Combined License Application Review STP Units 3 and 4

Safety Panel 1

November 19, 2015

Tier 1 Departure On I&C Architecture

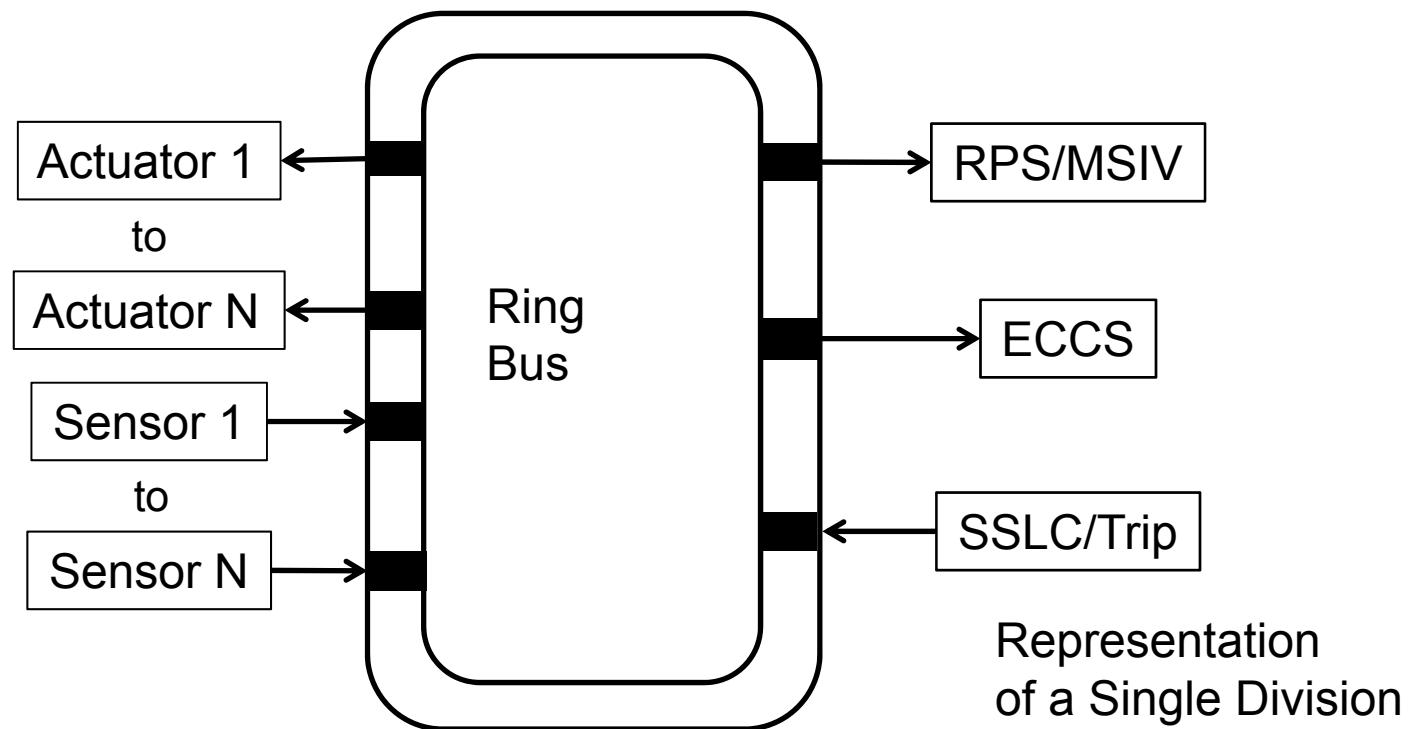
- **Diverse digital platforms are used for the Engineered Safety Features System and the Reactor Trip System**
- **Changes enhance protection against failures**

- **Review based on current regulations and staff guidance**
- **Staff concluded the modified I&C design conforms with current requirements**

Certified U.S. ABWR Ring Bus Design

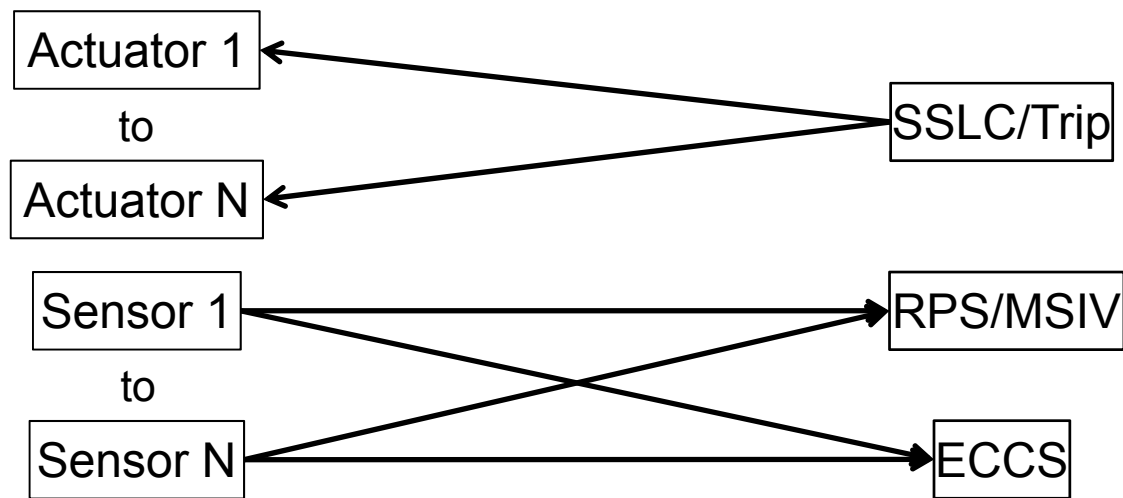
- **Selection of digital instrumentation and control (I&C) platforms resulted in changes to I&C architecture**
- **Data communication design changed the most**
